## LAND USE APPLICATION - COMPLETENESS REVIEW

<b>Subject Property:</b>	5660 Commercial Street SE
<b>Reference Number:</b>	24-115890
<b>Application Type:</b>	Class 2 Site Plan Review
<b>Date Application Accepted:</b>	July 26, 2024
<b>Applicant:</b>	Marcus Lima <a href="mailto:marcusl@gbdarchitects.com">marcusl@gbdarchitects.com</a>
<b>Contact:</b>	Same as applicant

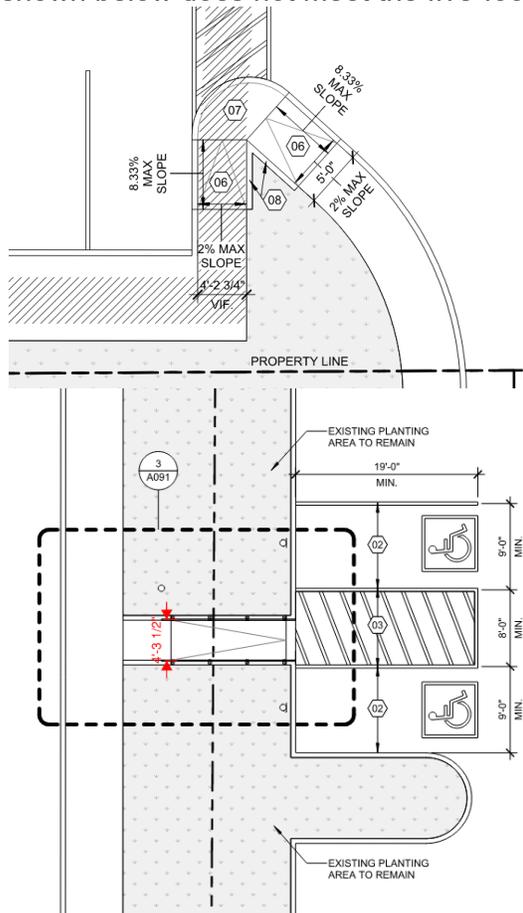
<p><b>800.065(b)(1)(A) Width of Pedestrian Paths</b></p>	<p>All areas altered need to meet required five-foot width for pedestrian connections. The areas shown below does not meet the five-foot width.</p>  <p>Please alter these to show the required 5 foot width.</p>	<p>Addressed</p>
--	---	------------------
